Access Compliance Report Public Rights-of-Way (Curb Ramps)

Main Street: CORPORATE_DR Cross Street: ANTONIO_PKWY Location: SE

ADA ID: RPRK211115170215 Ramp Type: Type 1 - Perpendicular Diagonal Initial Pass/Fail: Fail Overall Compliance: No Severity Score: 20

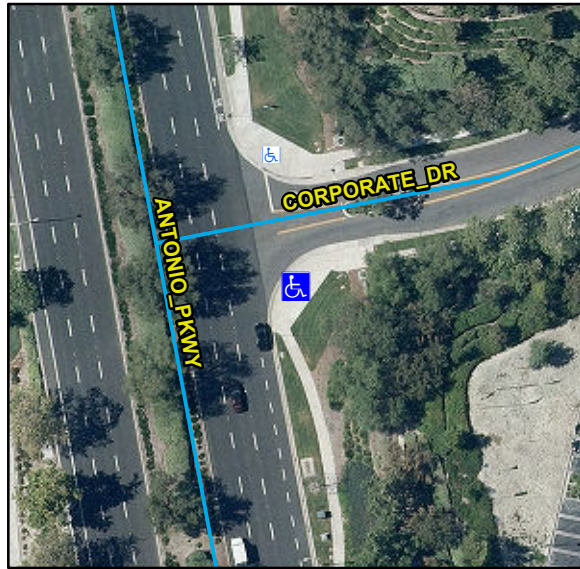
R304.2.2, R204.3, R304.5.1, R304.5.3, STD 1115

Remove & Replace Curb Ramp With Two New Directional Ramps or Equivalent.
